ADDENDUM NUMBER 1

- 1.01 DATE: April 7, 2015
- 1.02 PROJECT: Interior Renovations to the Mimosa - G Residence
Ramapo College of New Jersey
- 1.03 SNS PROJECT NUMBER: 4698G

INTERIOR RENOVATIONS
AT THE
MIMOSA - G RESIDENCE

Cert./Lic. No.
Date 02-03-15 Scale AS NOTED
Drawn By MD Checked By SG
Dwg. Title
FIRST & SECOND FLOOR ELECTRICAL DEMOLITION PLANS

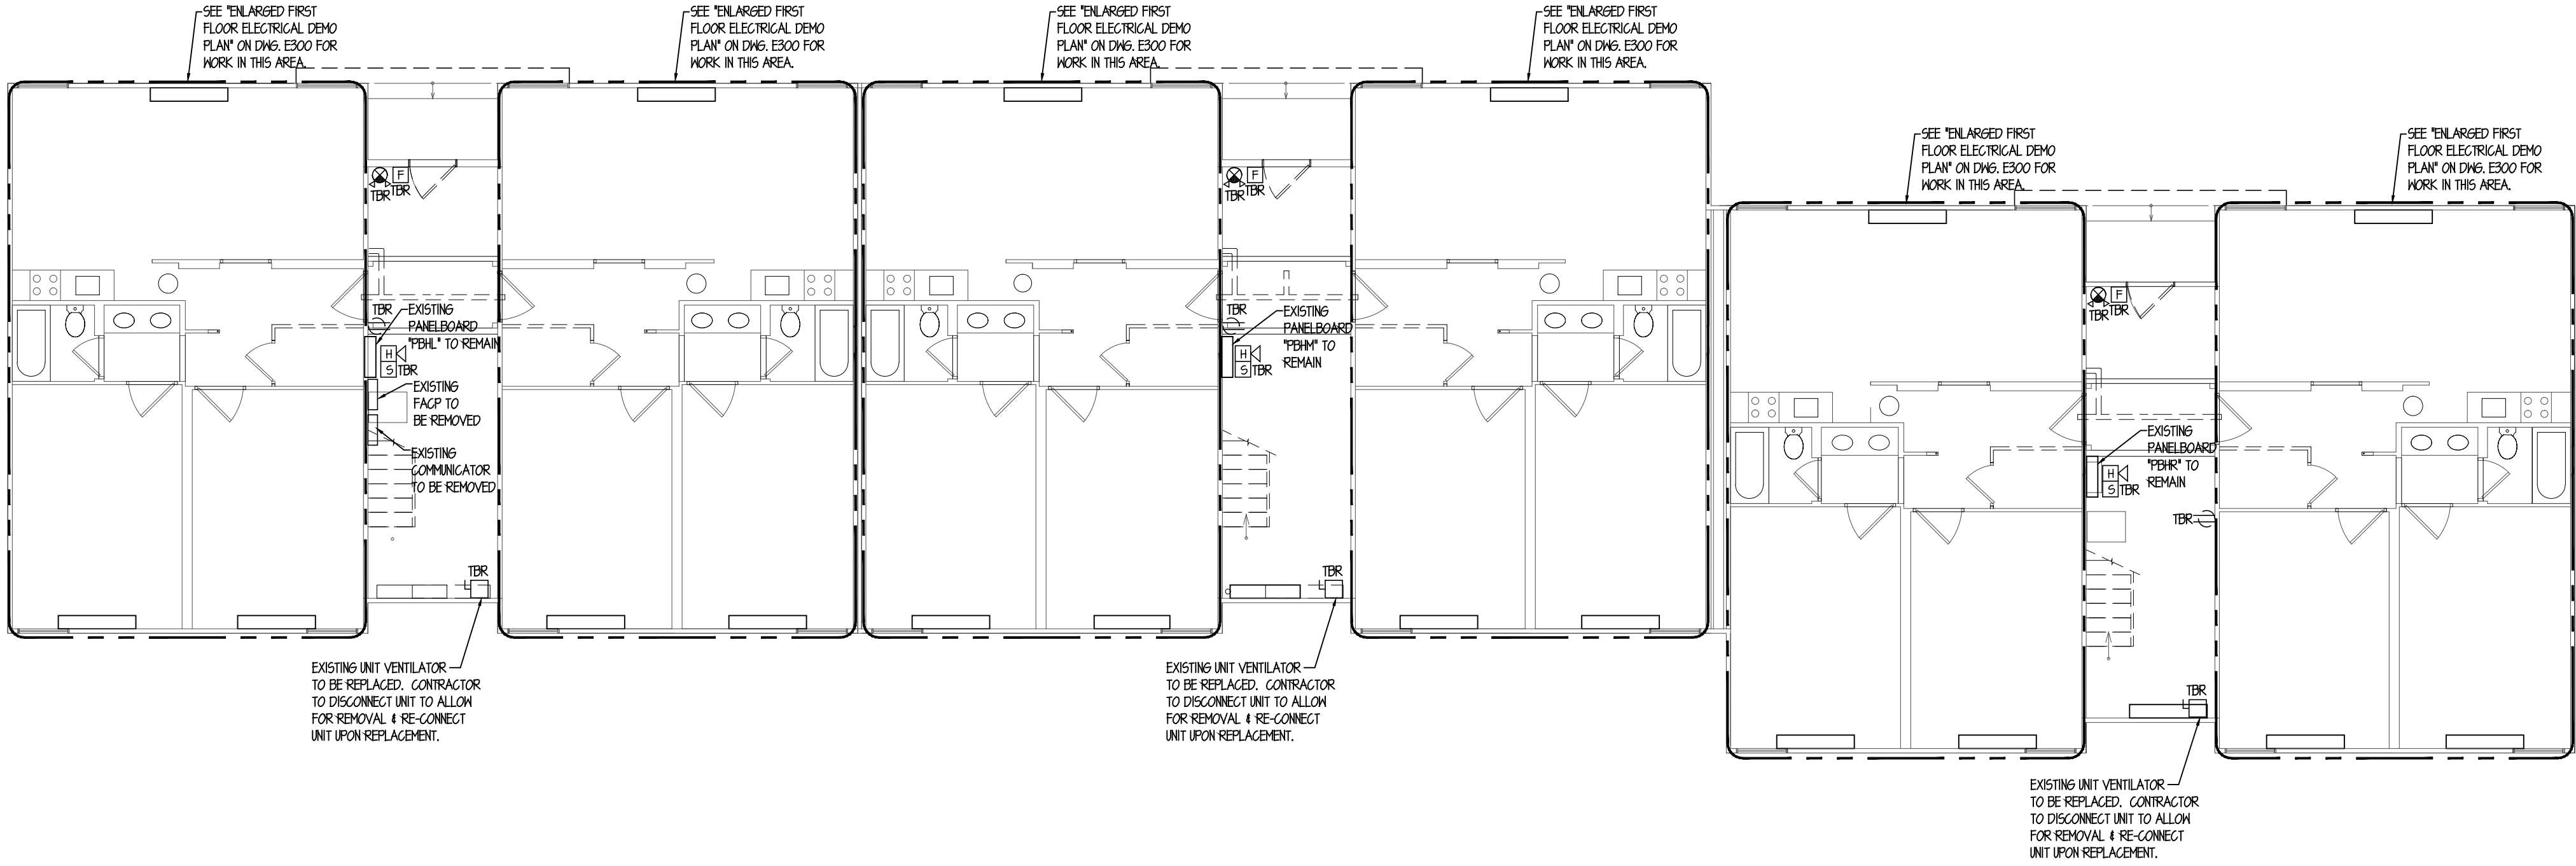
2. DRAWING E200, FIRST & SECOND FLOOR ELECTRICAL DEMOLITION NOTES:
 - 2.1. Revised Key Note #4 to indicate new security cameras to be furnished and installed by others.

- 2.2. Added power to new exhaust fan EF-1.
3. DRAWING E300, ENLARGED FIRST & SECOND FLOOR ELECTRICAL PLANS:
 - 3.1. Added note indicating that all demolition work is by others under separate contract and filed under separate DCA permit application.

HVAC NOTES, DETAILS AND SYMBOLS

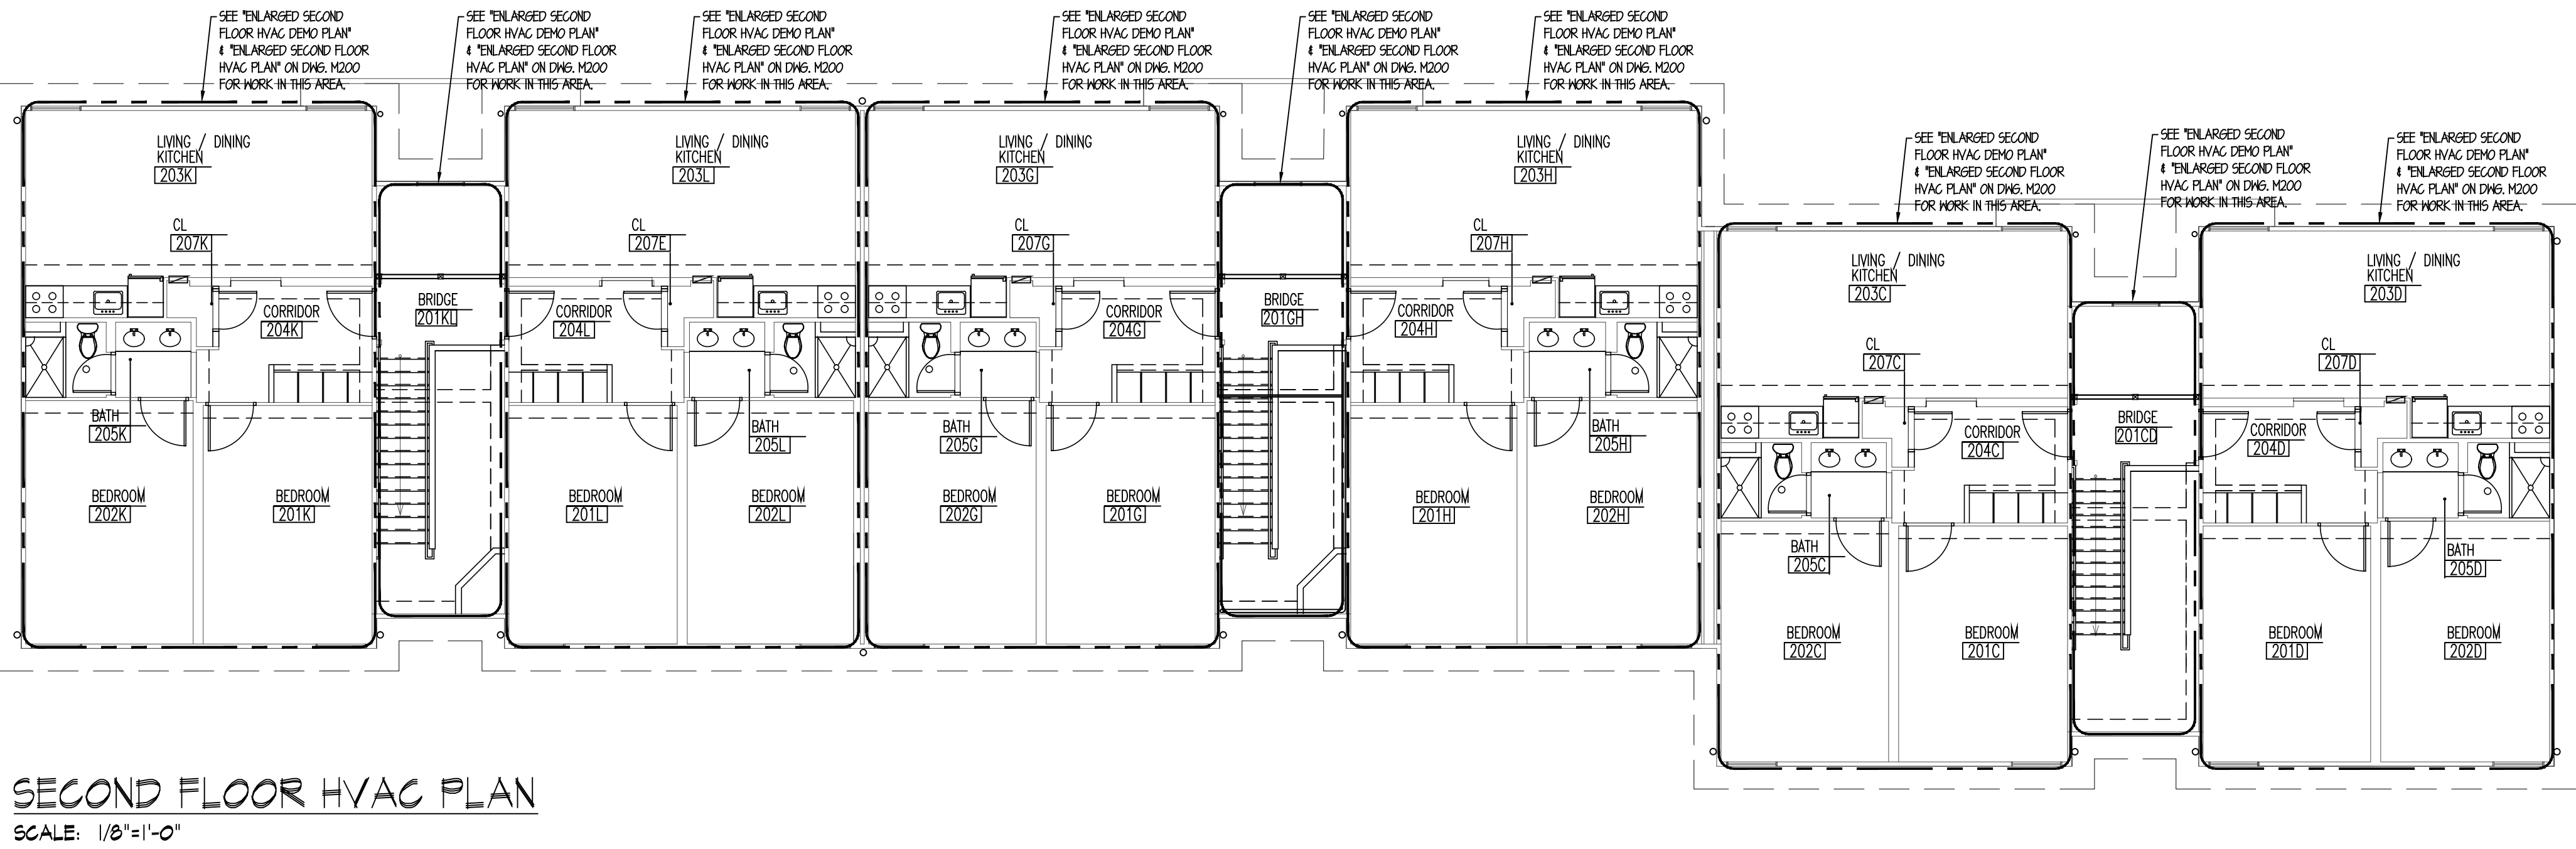
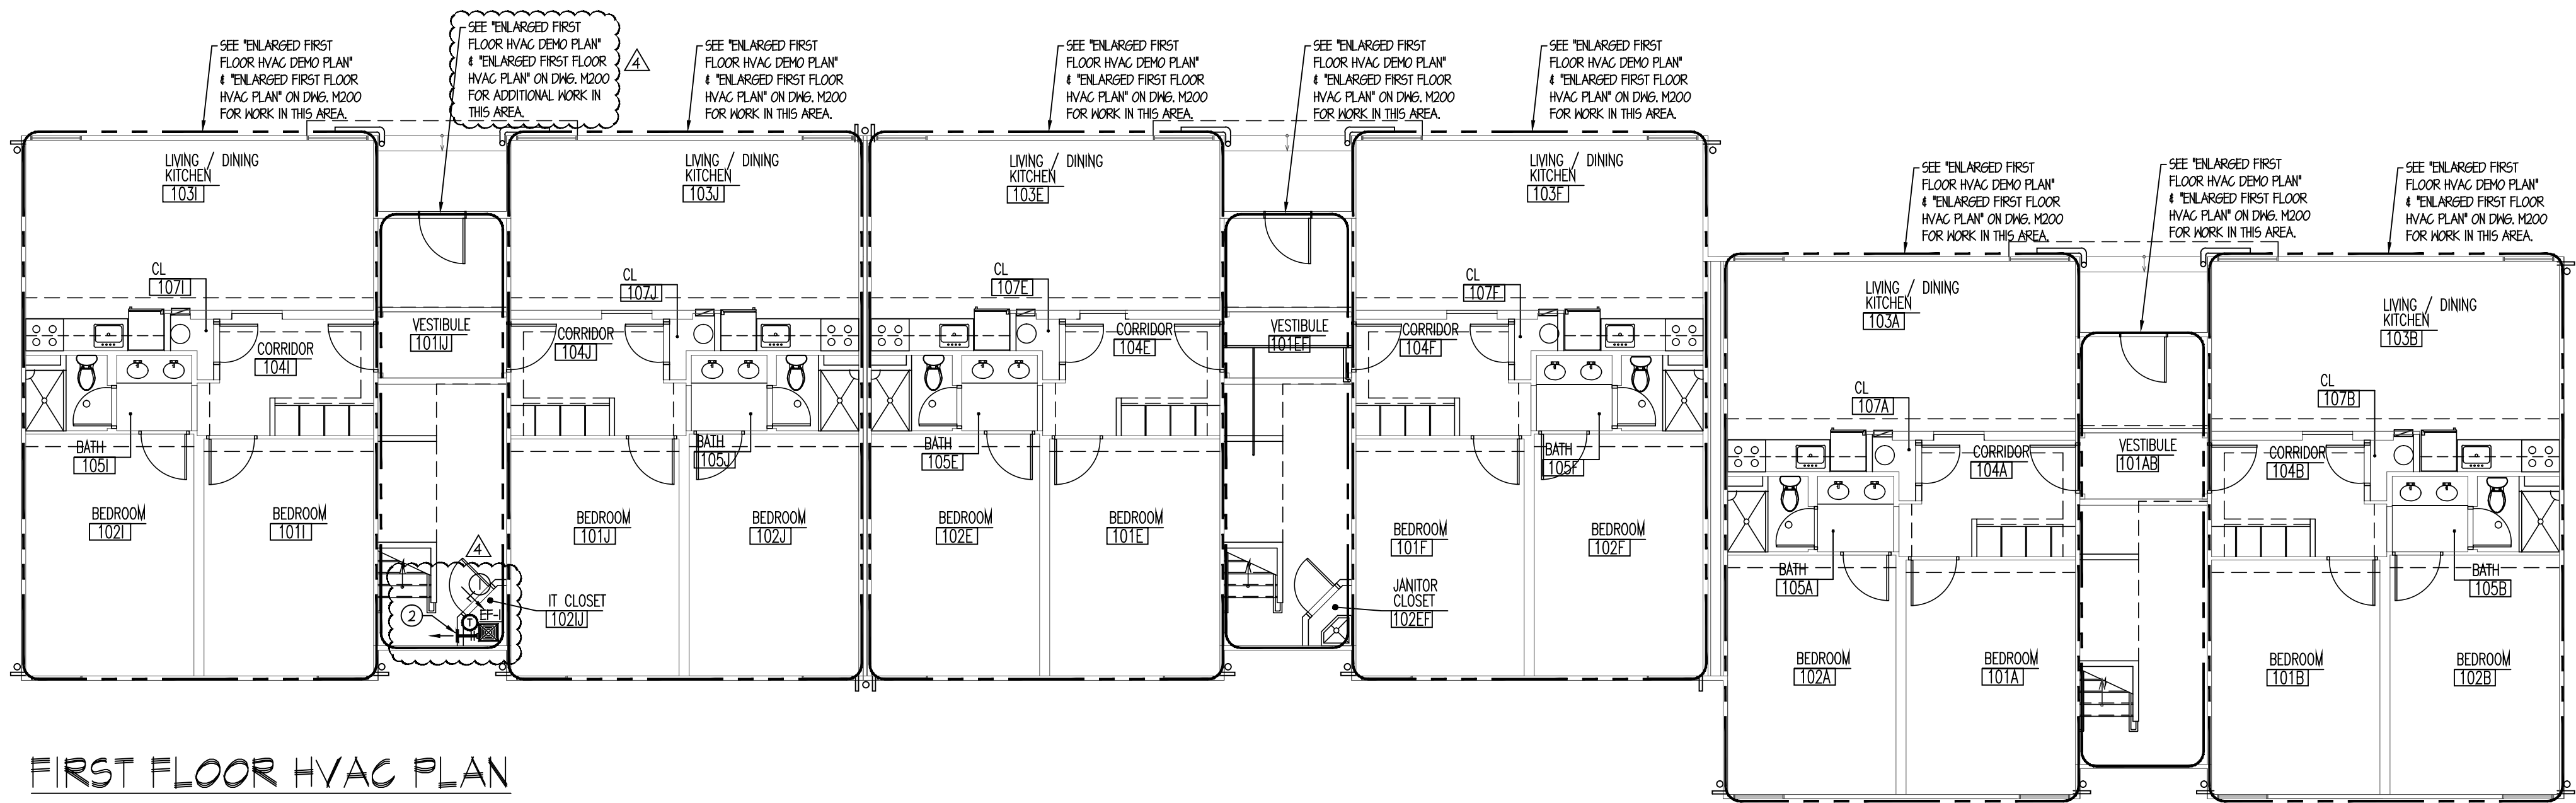
- 3.2.
4. DRAWING M001, HVAC NOTES, DETAILS, & SYMBOLS:
 - 4.1. Revised “HVAC Symbols for Alteration Work”.
5. DRAWING M100, FIRST & SECOND FLOOR HVAC PLANS:
